City of Portland, Maine – Building or Use Permit Application 389 Congress Street, 04101, Tel: (207) 874-8703, FAX: 874-8716

Location of Construction: 109 Huntington Ave		Owner: KTO Builders		Phone:		Permit No: 980820	
Owner Address:		Lessee/Buyer's Name:		Phone:		Business Name:	
Contractor Name: KTO Builders		Address: 13 Varney Mill Rd Windham, ME		Phone: 892-7813 04062 759-2101/759-3813		Permit Issued: JUL 29 1998	
Past Use: Proposed 1-fam		Proposed Use:		COST OF WORK: \$		PERMIT FEE: \$ 25.00	
				FIRE DEPT. <input type="checkbox"/> Approved <input type="checkbox"/> Denied		INSPECTION: Use Group: Type:	
				Signature:		Signature:	
Proposed Project Description: Amend building Permit # 980506 Changed from Cape to Colonial				PEDESTRIAN ACTIVITIES DISTRICT (P.A.D.) Action: Approved <input type="checkbox"/> Approved with Conditions <input type="checkbox"/> Denied <input type="checkbox"/>		Zoning Approval: Special Zone or Reviews: <input type="checkbox"/> Shoreland <input type="checkbox"/> Wetland <input type="checkbox"/> Flood Zone <input type="checkbox"/> Subdivision <input type="checkbox"/> Site Plan maj <input type="checkbox"/> minor <input type="checkbox"/> mm <input type="check

PLOT PLAN
 for
 LOT #1
 at
 COPLEY WOODS, PORTLAND, MAINE

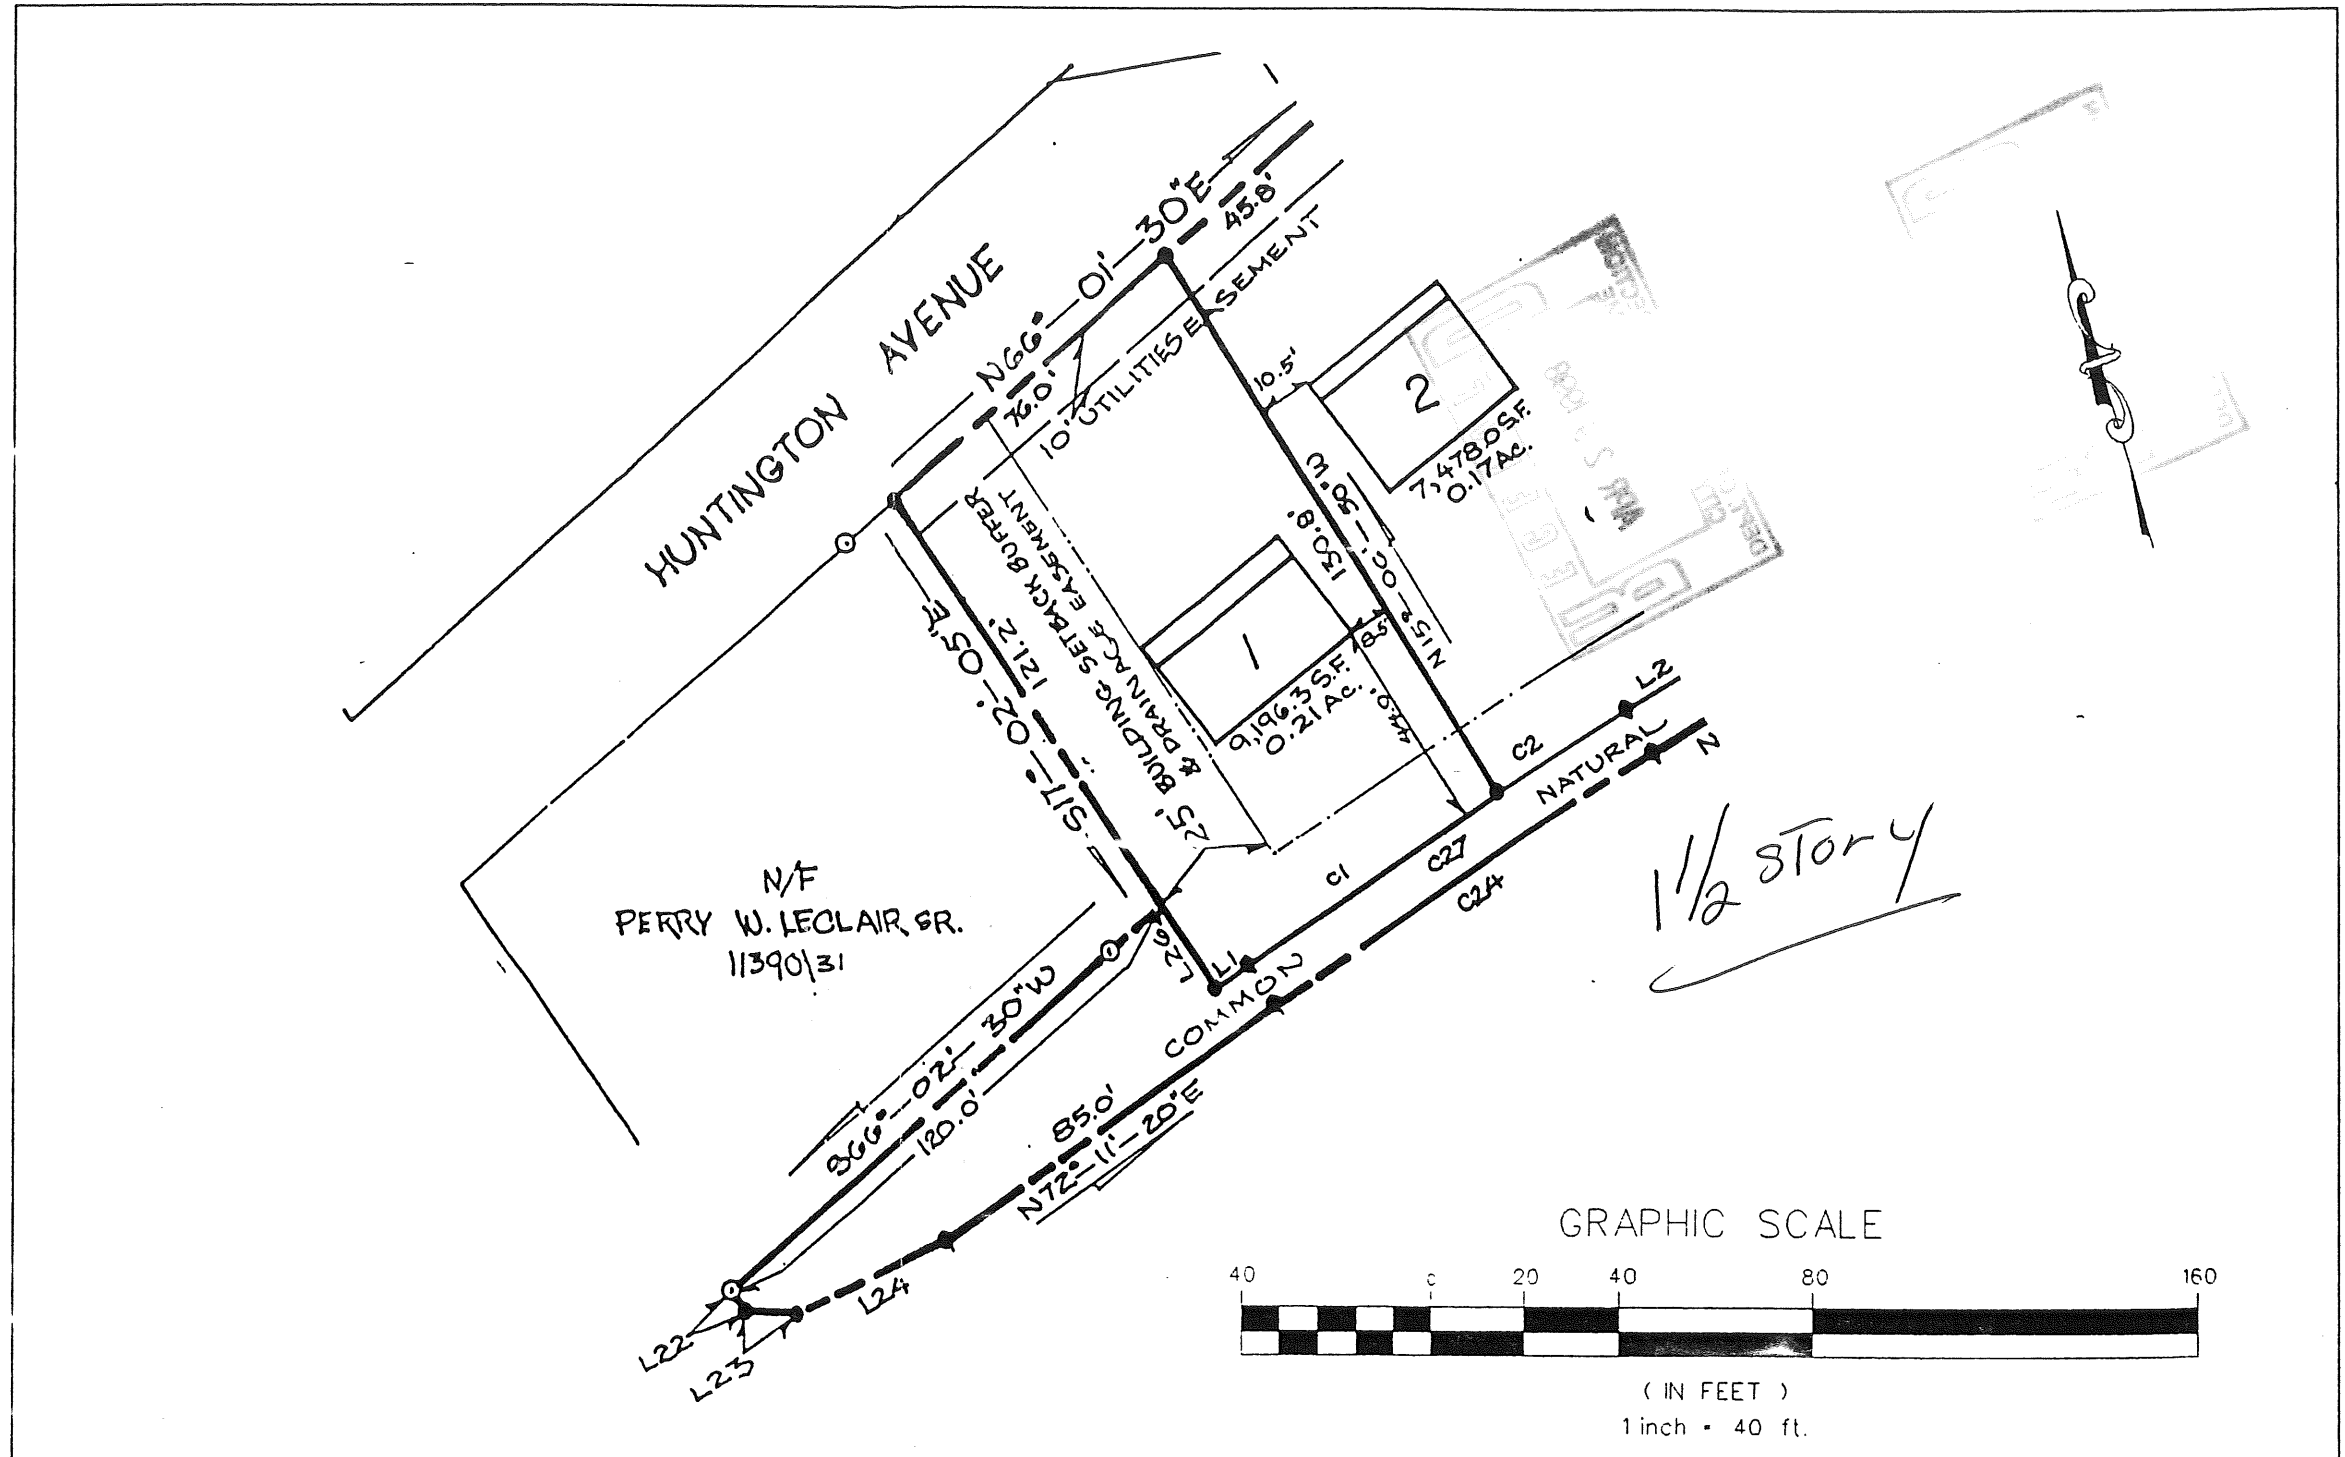
*This is not
reflecting the
construction
plans*
